Preliminary Consultation
MONTGOMERY COUNTY HISTORIC PRESERVATION COMMISSION
STAFF REPORT

Address:	7823 Overhill Road, Bethesda	Meeting Date:	2/10/2021
Resource:	Contributing Resource (Greenwich Forest Historic District)	Report Date:	2/3/2021
Applicant:	Stephen Smith Randal Mars, Architect	Public Notice:	1/27/2021
Review:	Preliminary Consultation	Staff:	Dan Bruechert
Proposal:	Building Addition, Accessory Structure Construction

1 Front Elevation . West
Scale: 1/4" = 1'-0"

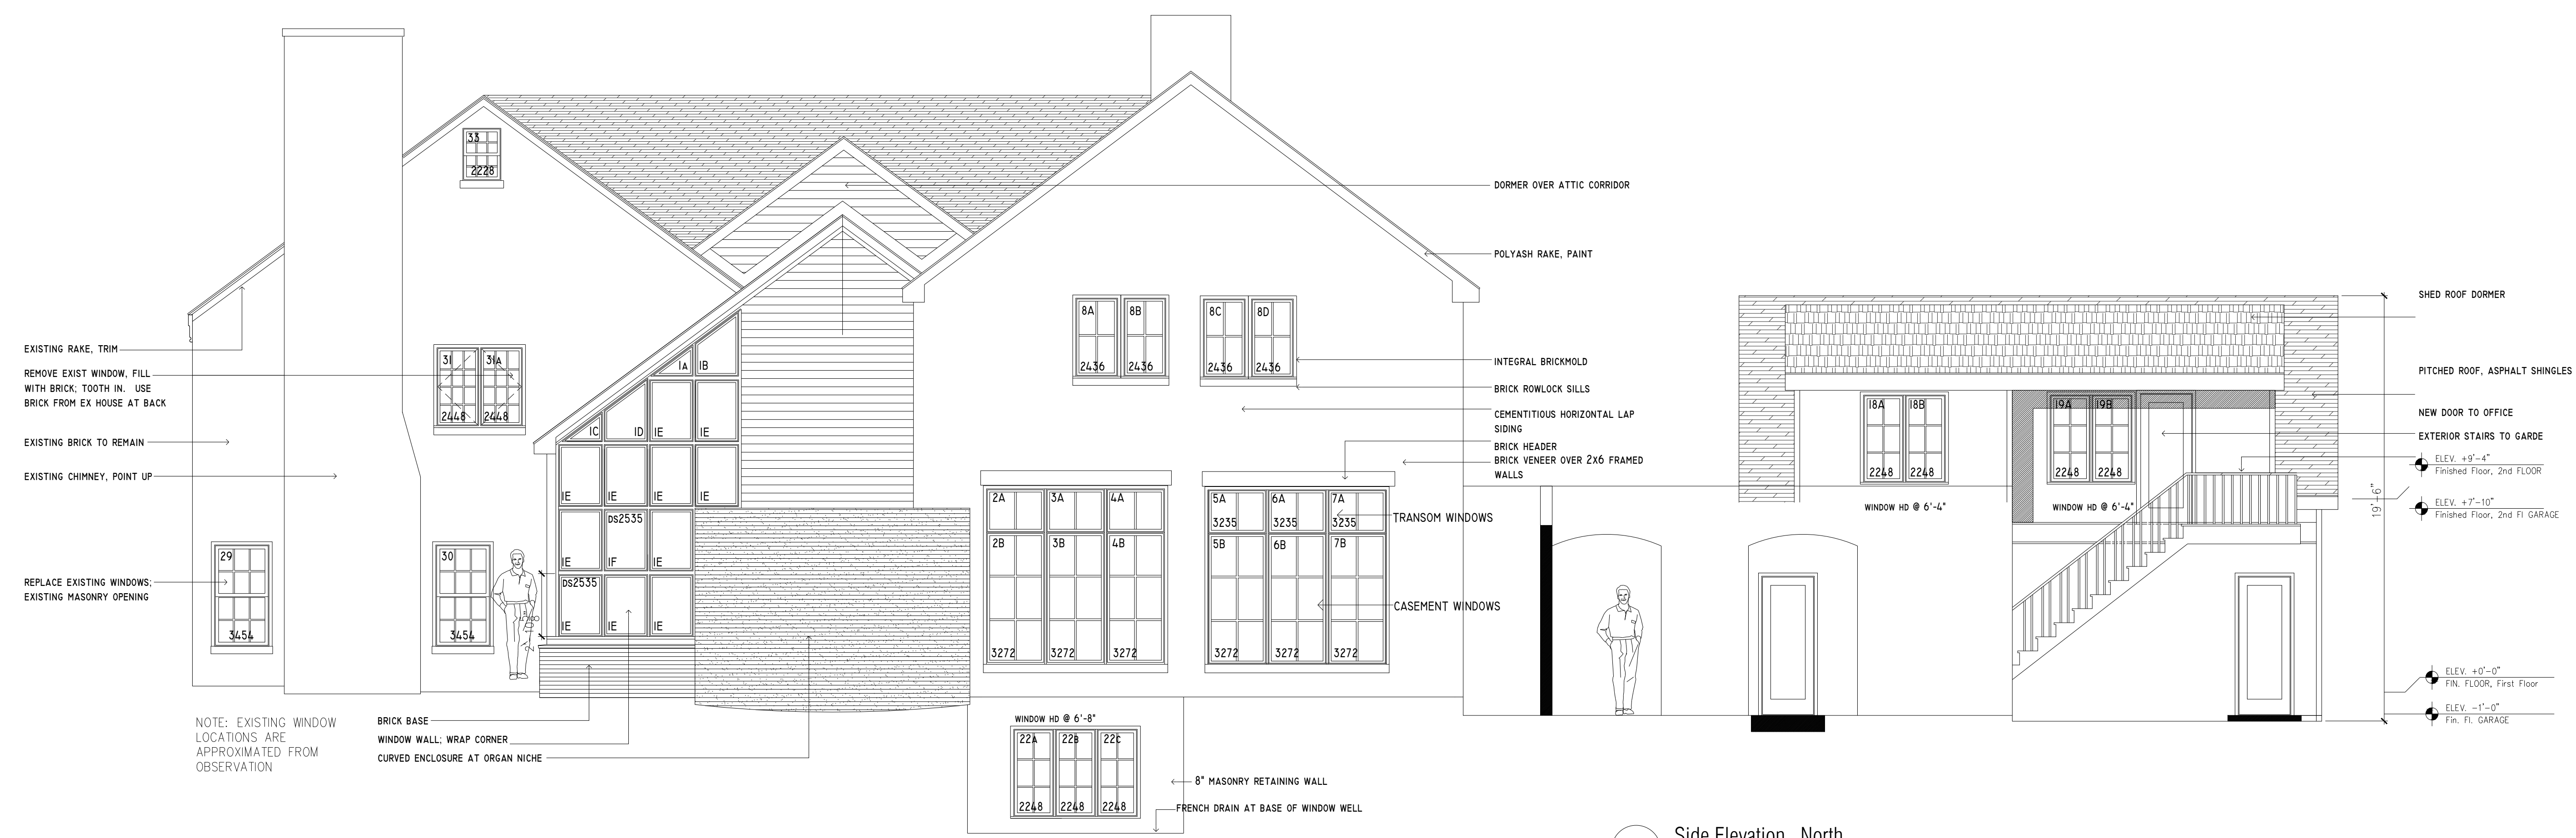
The applicant proposes to construct an addition at the rear of the house. The addition will be constructed out of two primary volumes, a one-and-a-half story side-gable addition constructed off of the right-rear corner, with a larger two-story addition to the rear. Both of the roofs will be covered in slate to match the historic house roof. More than half of the two-story addition is constructed behind the historic house. The proposed side-gable additions match the simple form of the historic house. The front of the visible one-and-a-half-story addition is dominated by a window wall that wraps around the right corner and has a brick foundation and horizontal lap siding. The rest of the addition has a combination of multi-lite casement and sash windows. The ridge of the rear gable appears to be taller than the principal gable of the house.

The second element to consider is the massing of the proposed addition. Much of the proposed addition projects to the right (south) of the historic house. The guidelines for additions (D4 and D5) focus on several factors including preserving the historic house as a recognizable entity, requiring side additions “must be demarcated by stepping back the front plane of the addition and by a change in the addition’s roofline,” providing ample spacing between houses with perspective requirements for side setbacks, and limiting the ridgeline of additions to no more than 3’ (three feet) above the historic ridgeline.

Staff finds that most of the requirements for the massing of the new addition appear to comply with what was considered when the residents of Greenwich Forest drafted the *Design Guidelines*. The side addition is stepped back two bays on the right elevation and its ridgeline is lower than the historic roof. Additionally, the side gable of the proposed addition appears to be taller than the historic gable ridge, but it does not appear to exceed the 3’ (three-foot) maximum. No information was provided regarding the distance between the proposed construction and the property boundaries, however, based on the aerial photo (Fig. 1) it appears that the addition will not run afoul of the setback requirement. Because the figures for roof ridge height and side setback are presented as maximum measurements in the *Design Guidelines*, those figures need to be included for the Historic Area Work Permit (HAWP) to be deemed complete. Staff also notes that the site rises by several feet from the right-of-way. A perspective drawing from the right side of the house at street level would be helpful to further evaluate the impact of the proposed construction.

from the right of way, however, the visible section primarily consists of a window wall and slate roof. Staff finds the form of the addition is compatible with the style of the house. The highly visible window wall will be viewed as a clearly contemporary feature, however, is it compatible and in keeping with the prevailing style of the house? Staff finds that it is. The visible portion of the proposed addition reflects the form of the historic house, i.e. a rectangle footprint with a simple side gable slate roof. The visible architectural details of the addition include the brick foundation/knee wall, matching the exterior material of the historic house and a window wall. The window wall is a contemporary feature with its roots in mid-century architecture. This section of the addition is devoid of all other ornamentation. Staff finds that this lack of ornament makes the form of the addition more compatible because it does not visually compete with the simple decorations on the historic house—primarily the multi-lite windows and shutters. Staff recognizes that these drawings are in a preliminary stage, but it appears as though the historic exterior wall may be visible through the window wall. If this is the case, this treatment would preserve all of the historic houses as a recognizable entity (see D4 and D5).

- The difference between the historic and taller addition gable and
- Distance between the house and the neighboring house.

2 Front Elevation at Garage, West
Scale: 1/4" = 1'-0"

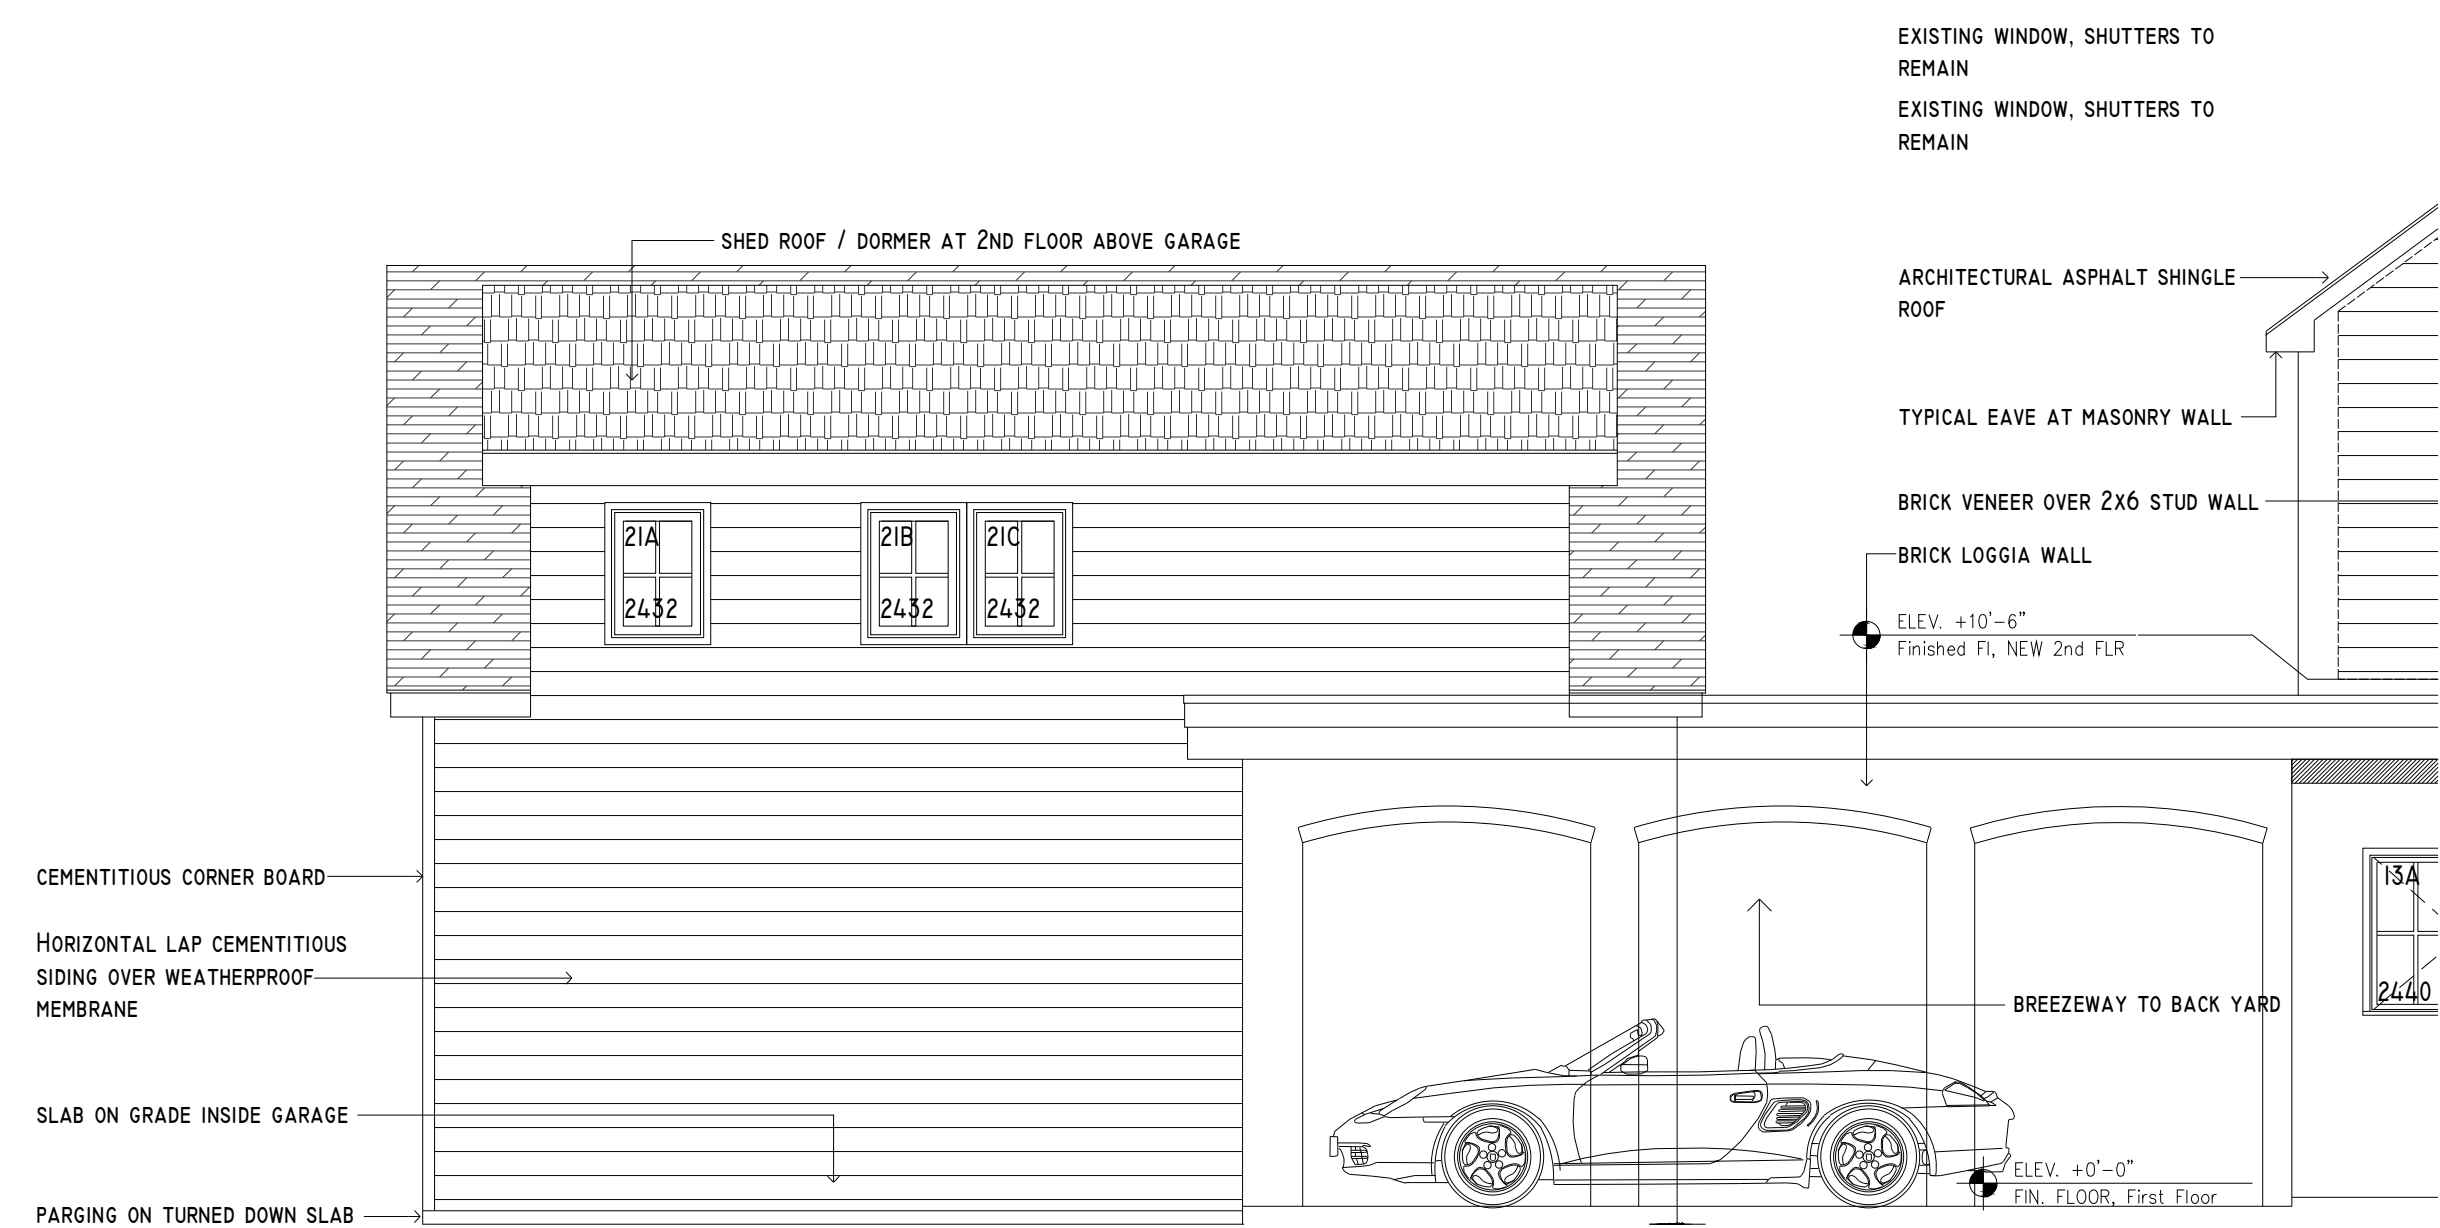
In the rear of the lot, to the left of the house, the applicant proposes to construct a one-and-a-half story garage. The garage will be covered in lap siding to match much of the building addition and have wood vehicle doors and multi-lite casement windows facing the street. The garage roof will be covered in asphalt shingles. An exterior staircase on the south elevation will provide access to the second story. The garage will be connected to the house by a brick loggia.

Accessory buildings in the Greenwich Forest Historic District need to adhere to the same requirements as building additions. The design and materials need to be compatible with the historic house and the ridgeline may be no more than 3' (three feet) tall than the historic one. The most important consideration for accessory structures is that they may not exceed 5% lot coverage unless the house and accessory building are less than 30% total lot coverage. In those instances, the accessory structure can cover up to 7% of the total lot. The proposed accessory structure will cover 5.11% of the lot. With the proposed addition (discussed above), the proposed total lot coverage is 24.46%. This complies with the requirements of the *Design Guidelines*; however, the applicant must provide these numbers at each stage of the proposal in their own table for review and analysis. There is not enough information at this stage to analyze the impact of this building feature vis-à-vis the site elements or the streetscape.
